ADDENDUM #1

TO CONTRACT DOCUMENTS ENTITLED: Project #CP241341 Various Locations – FY24 Summer Paving Project – Asphalt

CONSULTANT: MECO Engineering Co., Inc.
2701 Industrial Drive, Jefferson City, MO 65109
573-893-5558
Project Number 473-070

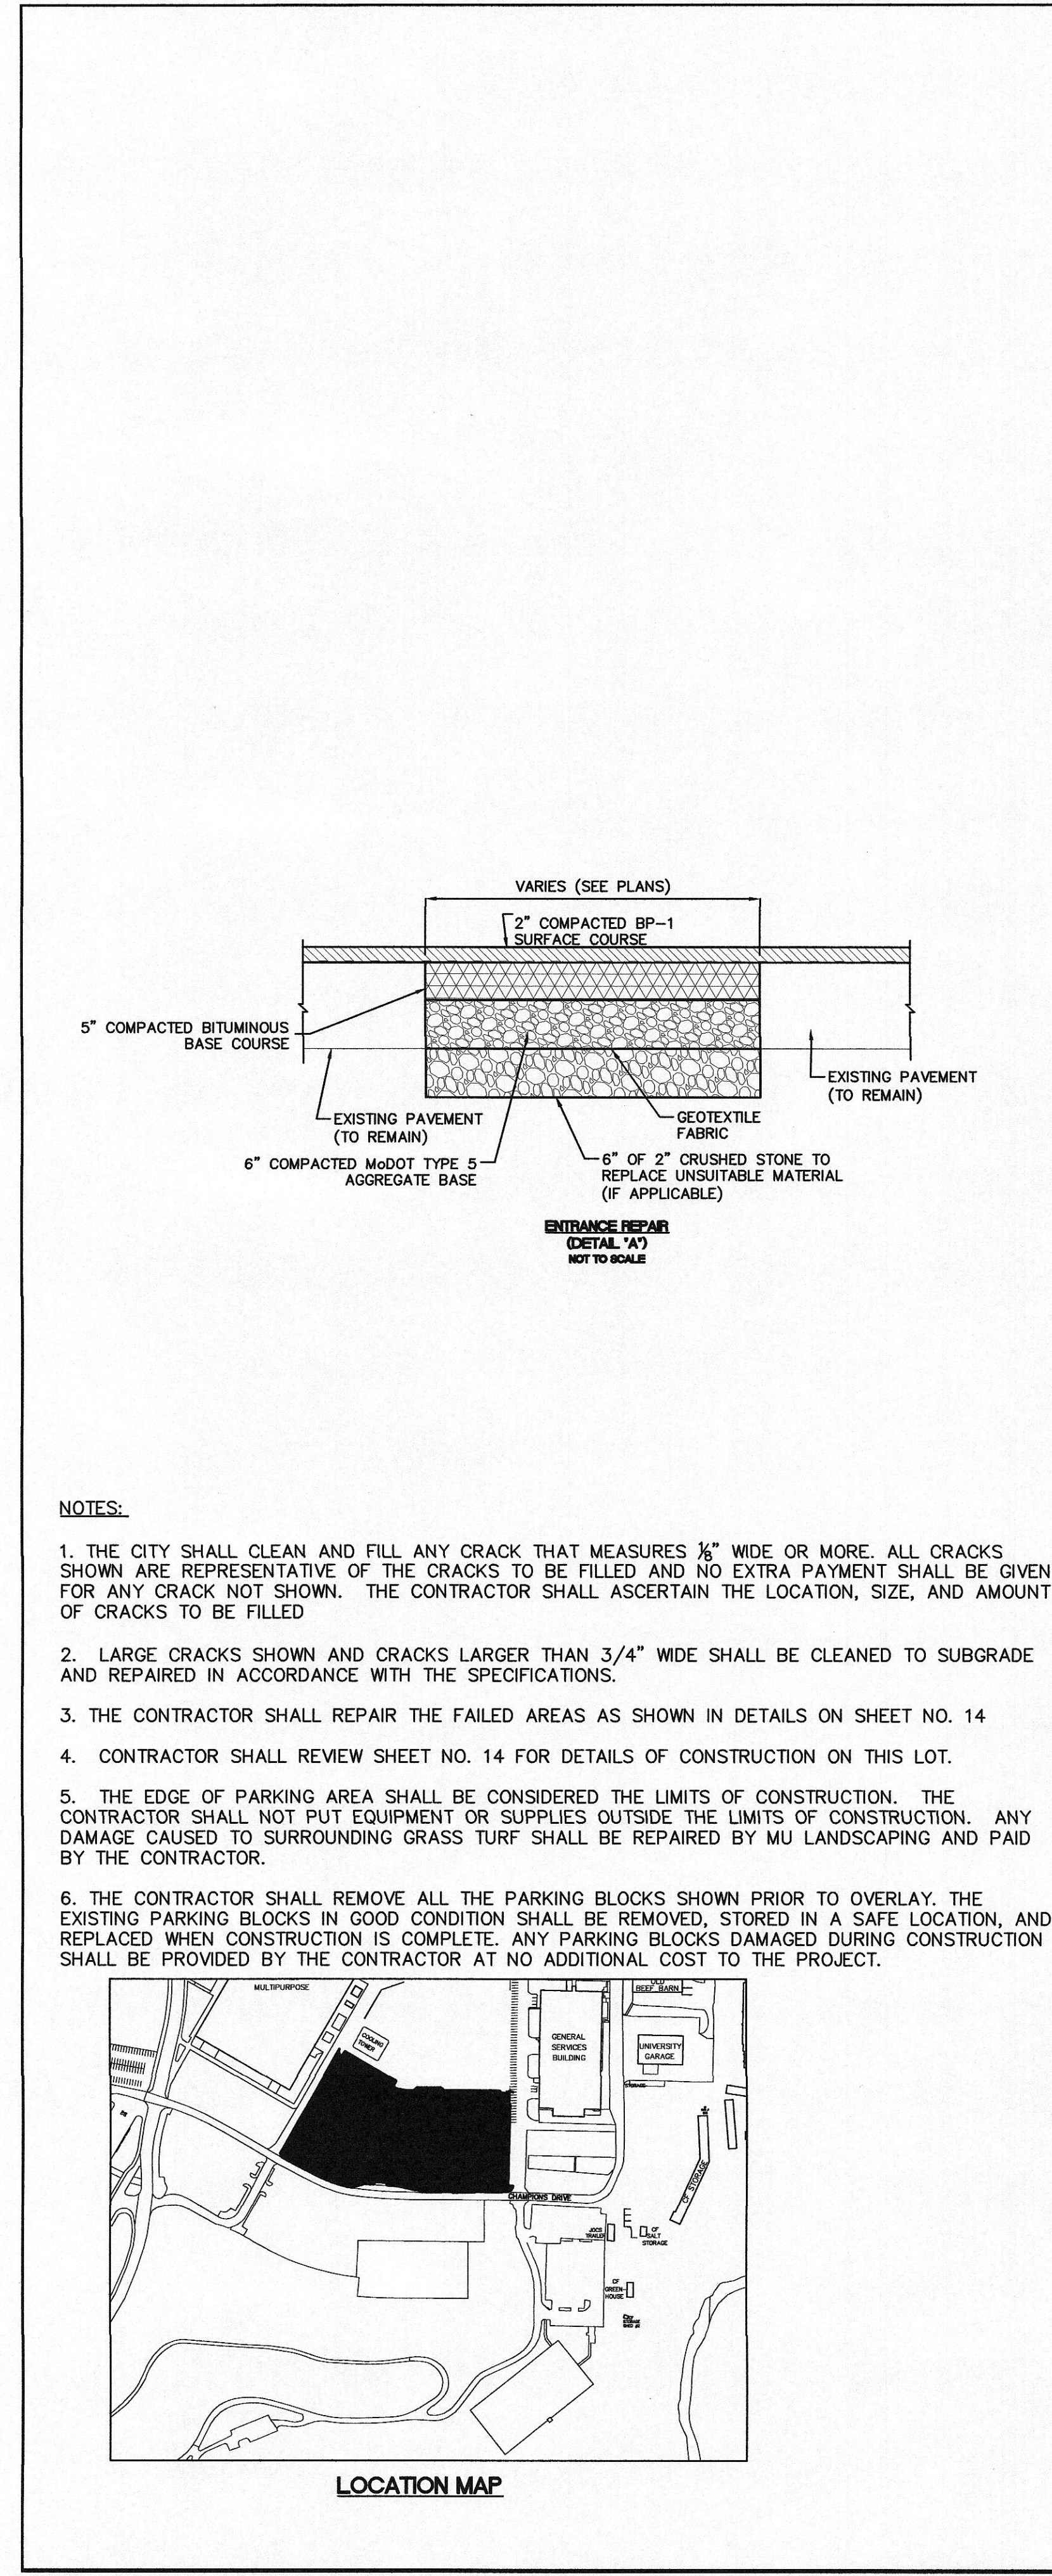
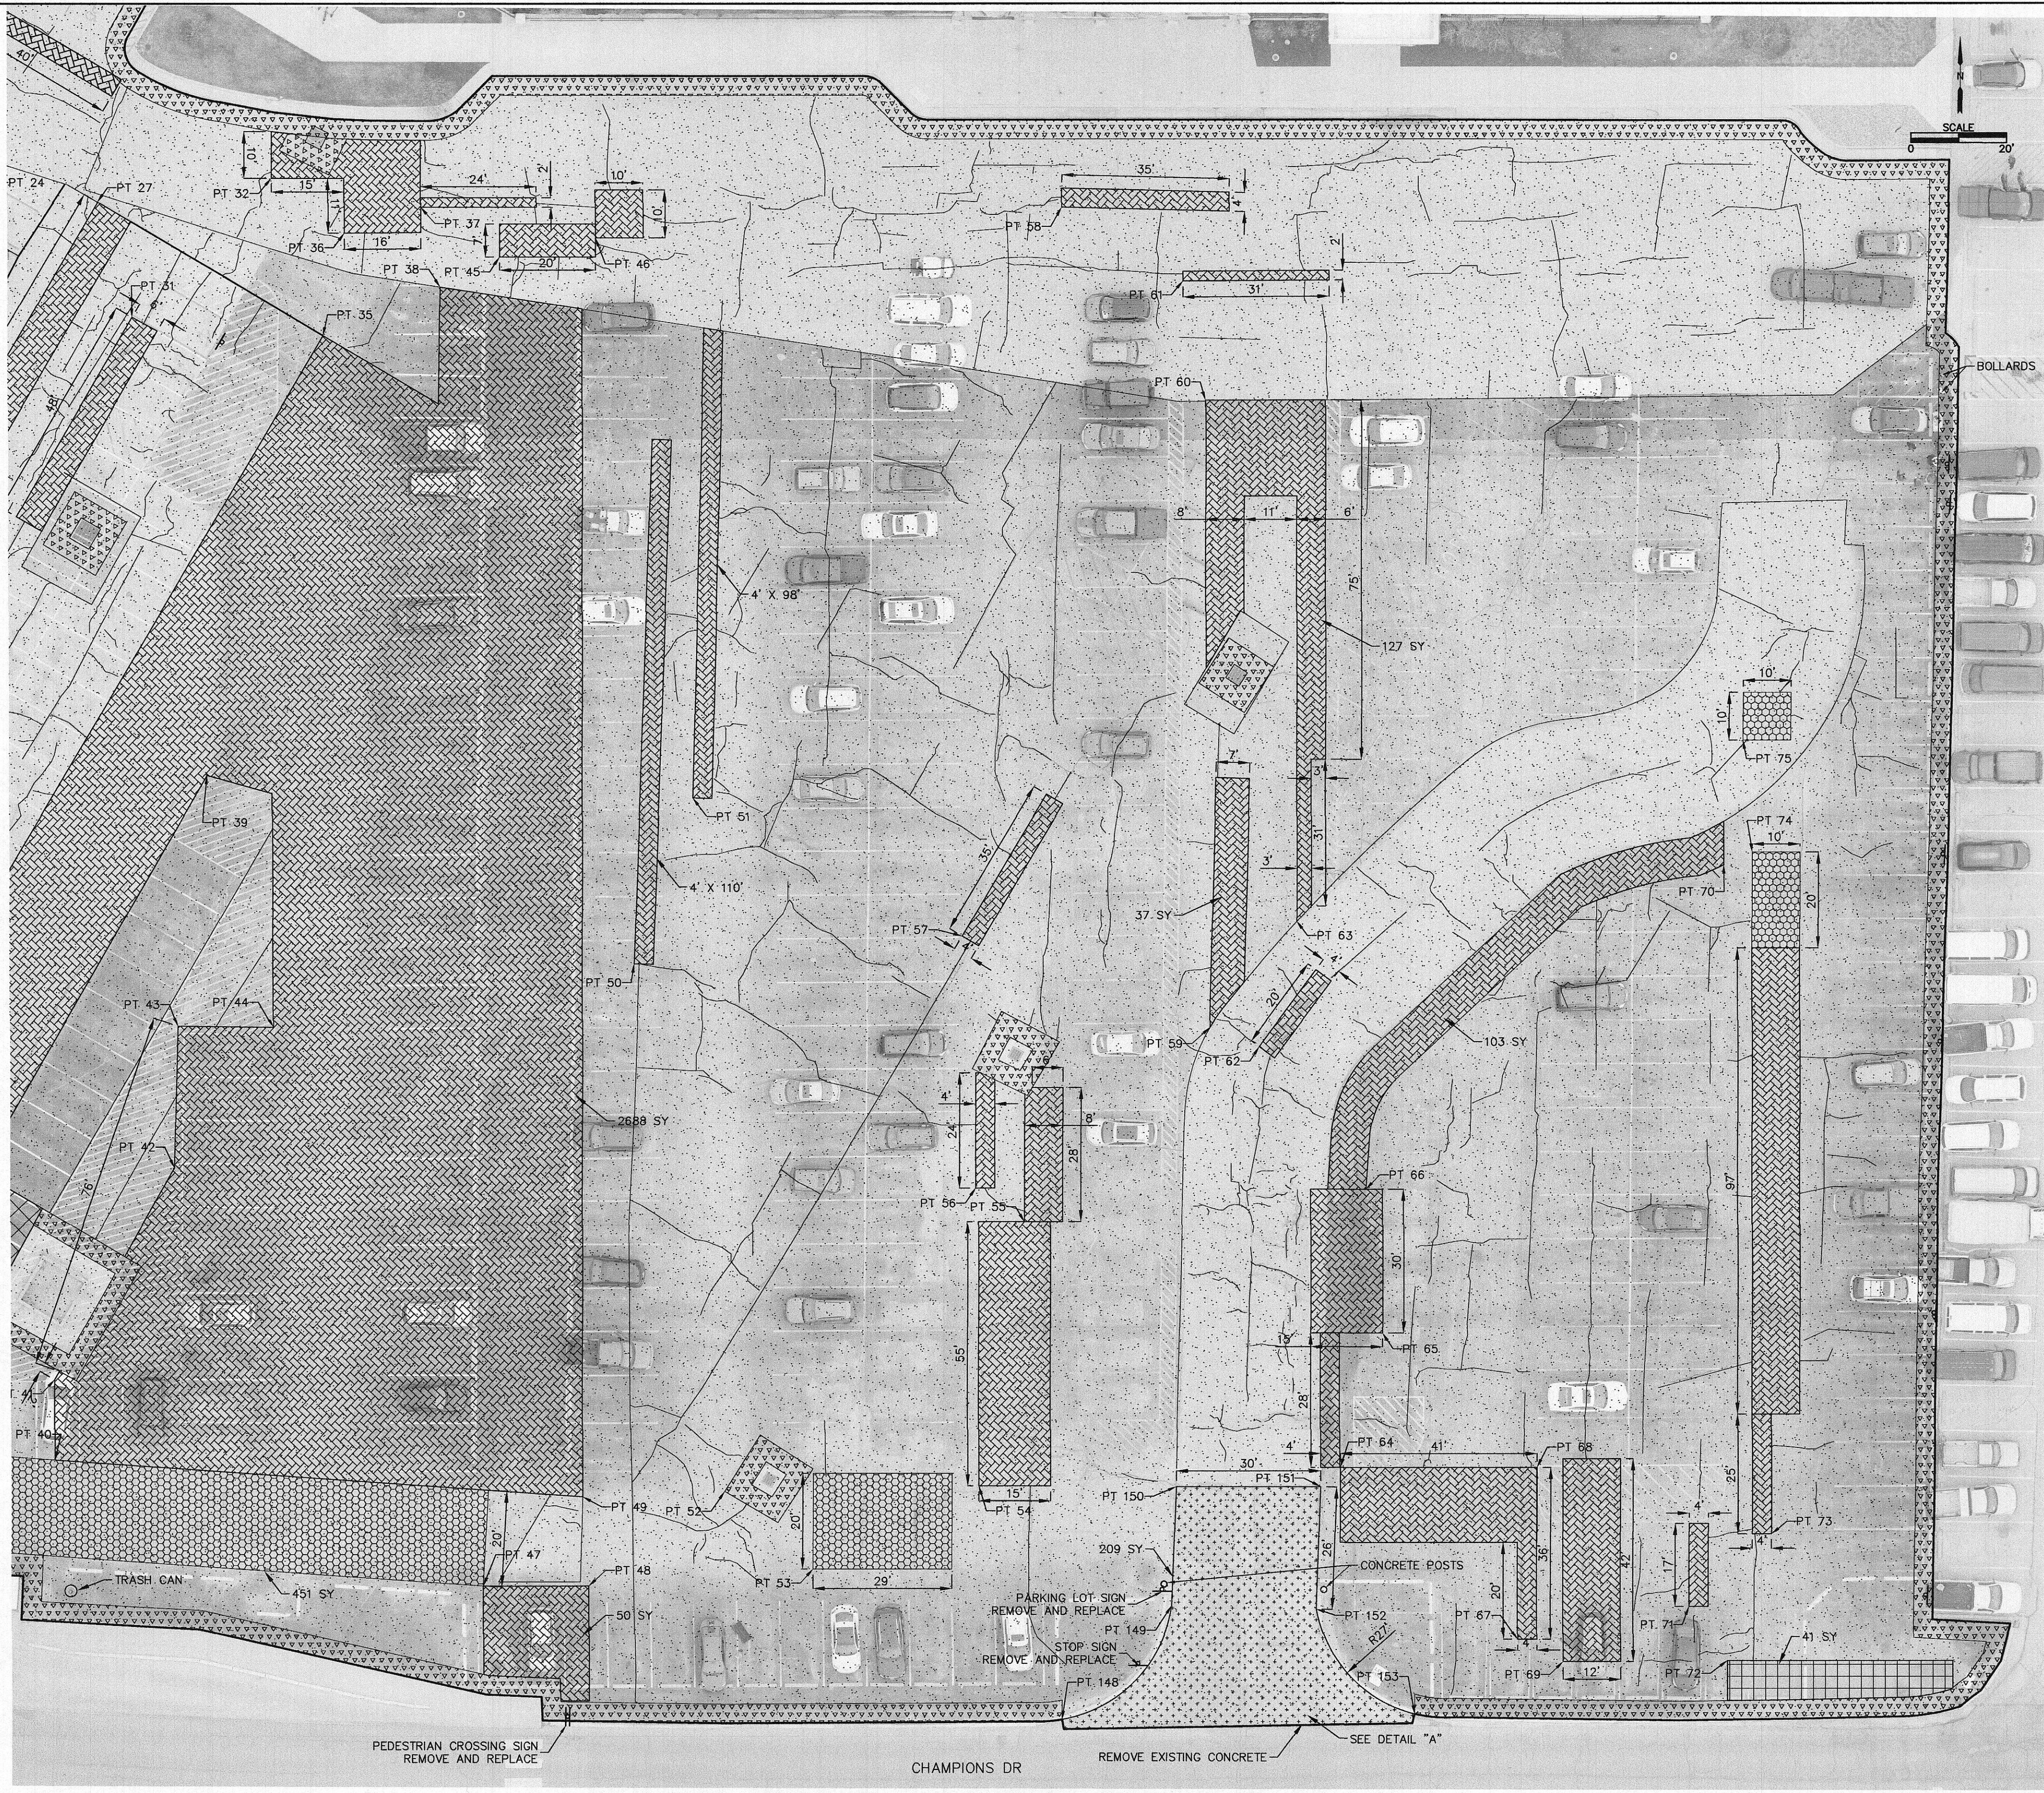
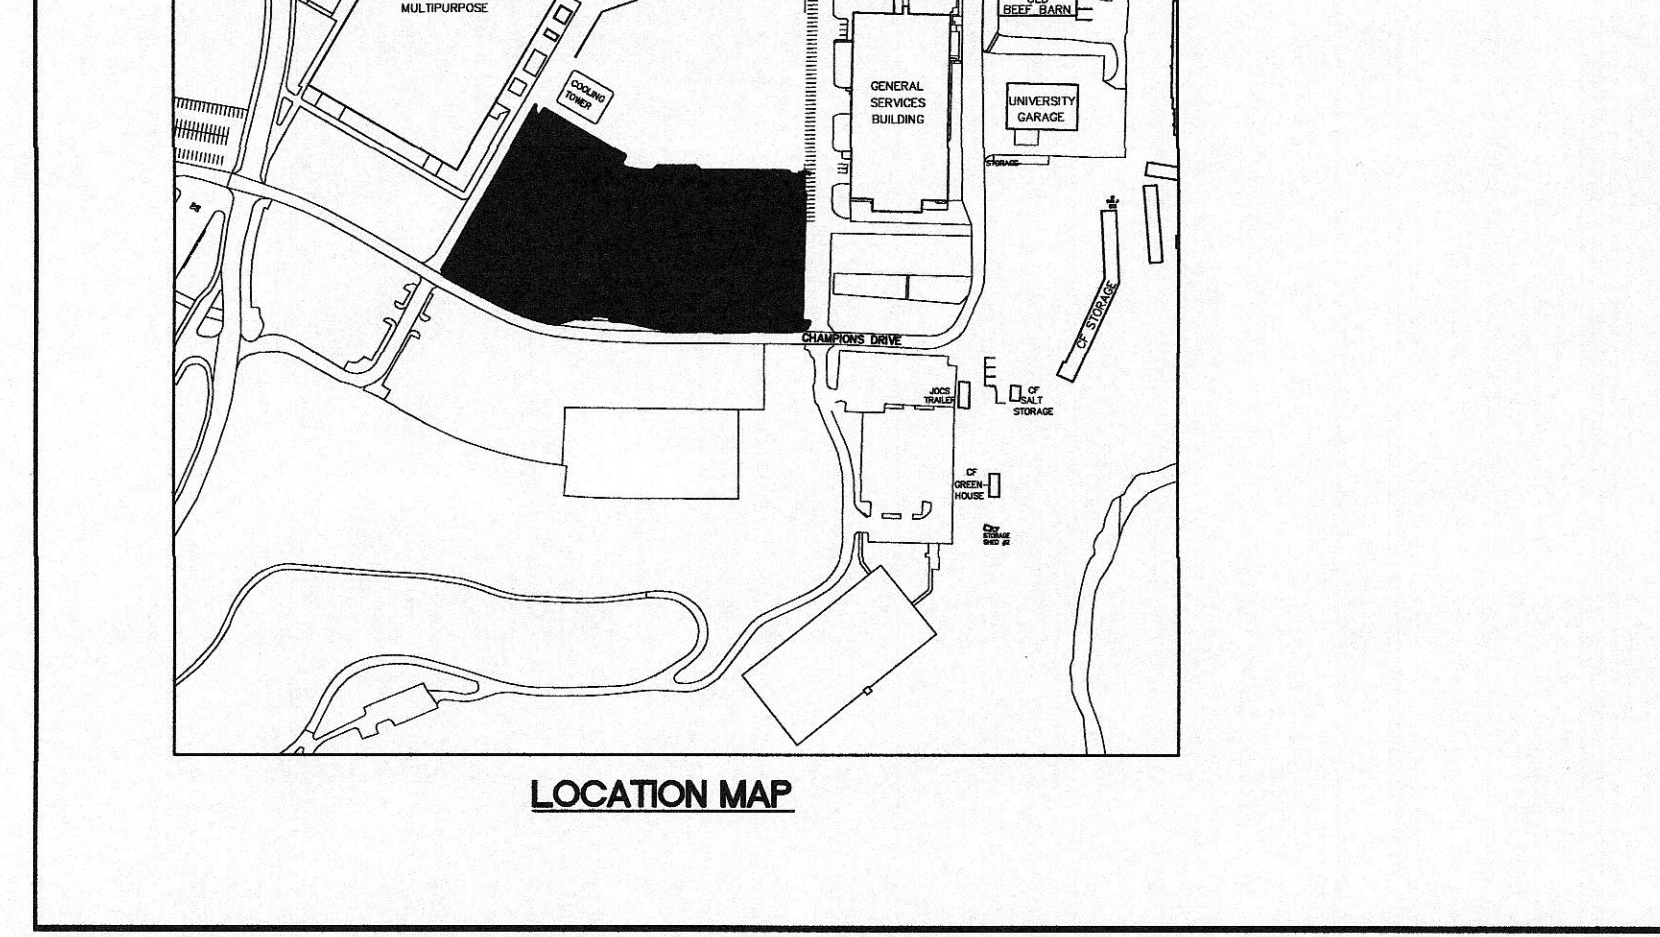
- 4) Add Section 1.F Index of Drawings: The index of sheets has additional sheets representing the Alternate Bid: Sheet No. 15: Alternate Bid No. 1, SG4/M Sign Location and Traffic Control; Sheet No. 16 and 17: Alternate Bid No. 1, SG4/M Repair Plan; and Sheet No. 18 and 19: Alternate Bid No. 1, SG4/M Striping Plan

- 1) Sheet No. 1 Cover Sheet: Change the Drawing Index to include:
Sheet 15: Alternate Bid No. 1, SG4/M Sign Location and Traffic Control
Sheet 16 and 17: Alternate Bid No. 1, SG4/M Repair Plan
Sheet 18-19: Alternate Bid No. 1, SG4/M Striping Plan
- 2) Add Sheets 15-19, marked Alternate Bid No. 1, to the Plan Set.
- 3) Sheet No. 3 Sign Location and Traffic Control, Detail SG7/A and SG7/B remove the two movable barricades indicated on the drive to the tunnel.
